**CITY OF BOULDER
PLANNING BOARD AGENDA ITEM**

AGENDA TITLE: Public hearing and consideration of a Site and Use Review (LUR2016-00056 & LUR2016-00057) proposal to establish a retail store and café use at 1815 Pearl St. The total square footage of the tenant space is 2,642 square feet with 1,984 square feet of retail and 658 square feet of café space with 40 interior seats. A concurrent site review has been submitted for consideration of an 89% parking reduction.

Rapha Racing

1815 Pearl St.

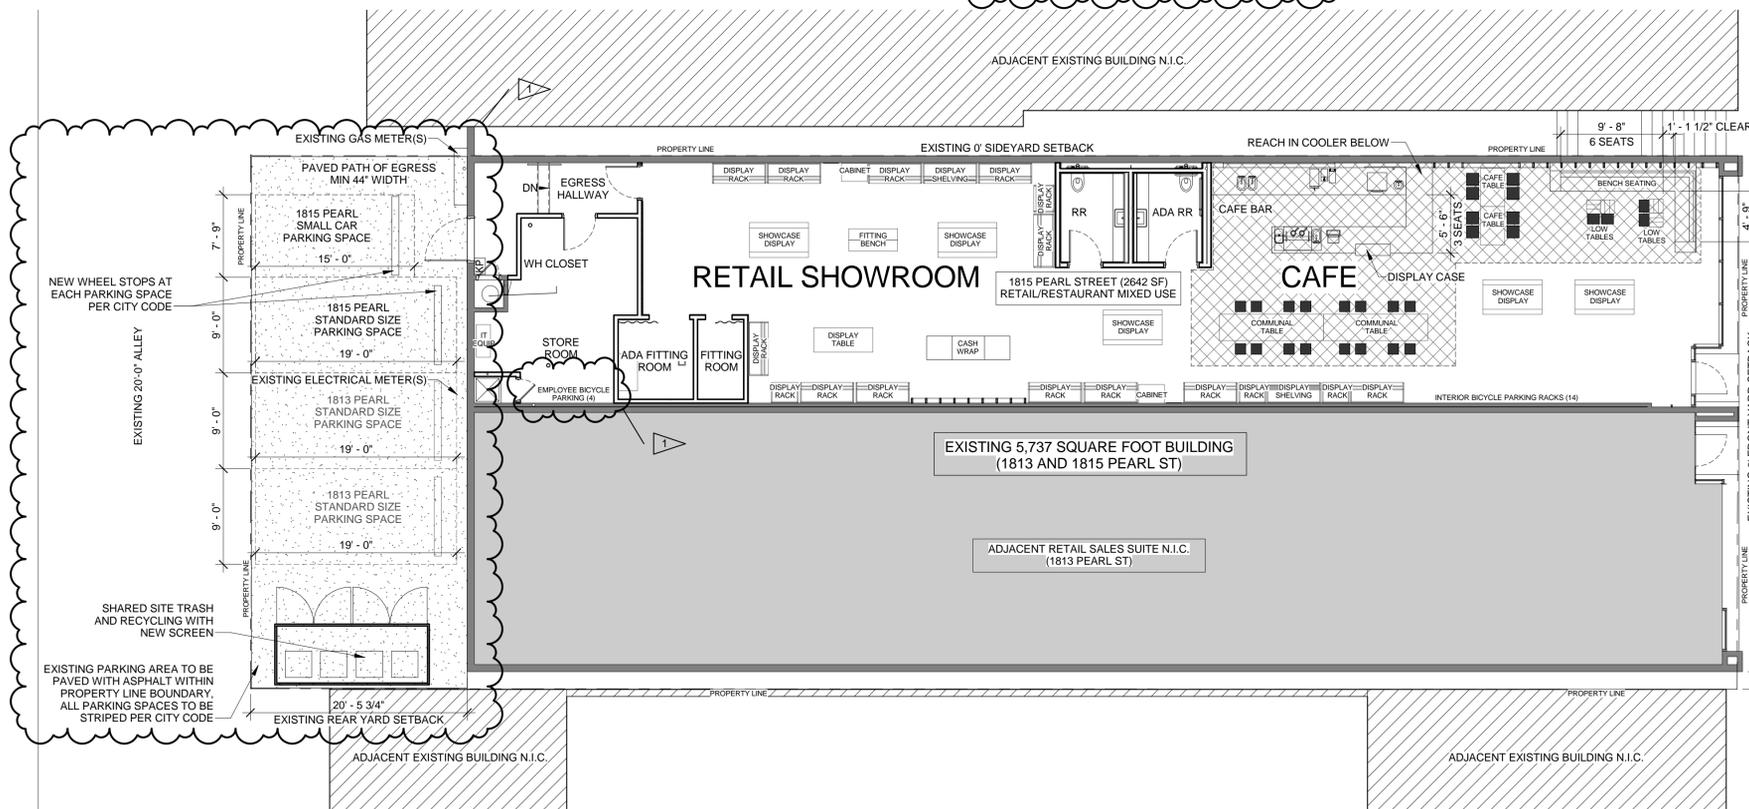
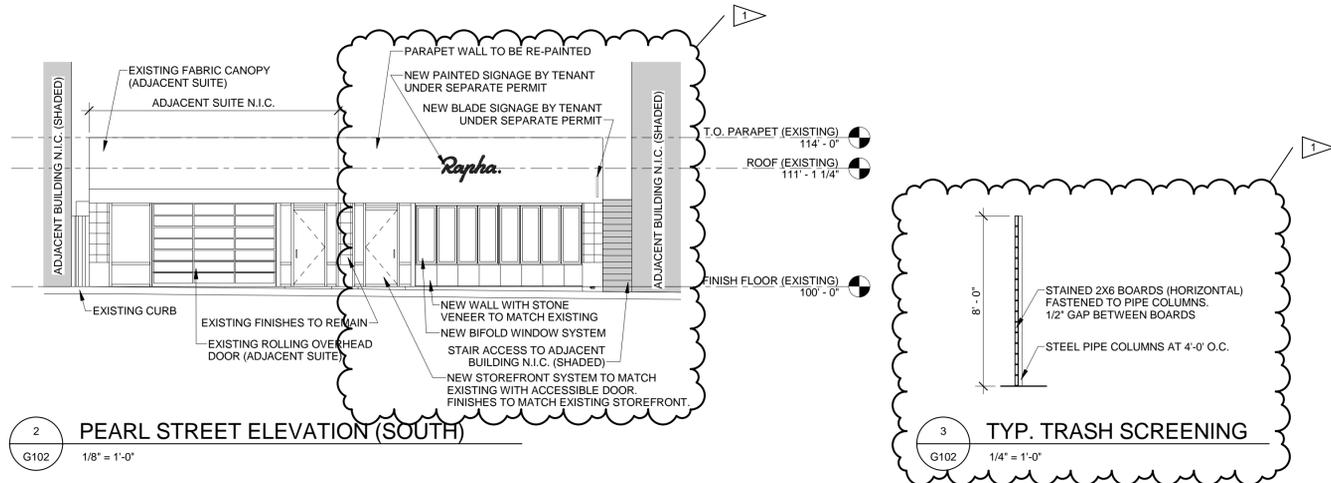
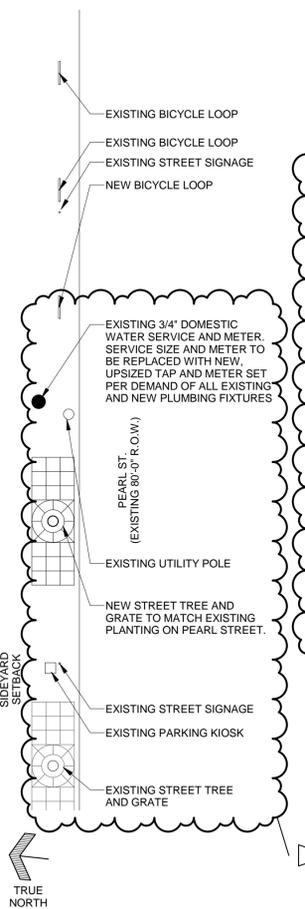
1. Pursuant to section 9-9-6(5)(B) of the B.R.C. 1981, please revise the site plan to show the parking area being paved with asphalt concrete or other similar permanent hard surface material.

2. There are discrepancies between the Project Fact Sheet and the plans in regards to the number of parking spaces being provided. The Fact Sheet states that one standard space and one compact space will be provided while the plans show and list 2 standard spaces and 1 compact space. Please clarify and revise the plans accordingly.

5. In support of the proposed parking reduction and TDM Plan, please revise the site plan to provide a minimum of four long-term bike parking for employees in the store room.

1. Please remove or ghost in the auto parking spaces that are used by the adjacent tenant.
2. Add a note that auto parking spaces will be striped per city code.
3. Indicate code compliant wheel stops for each parking space.
4. Confirm the exact number of seats for the restaurant use and revise the site plan as necessary.
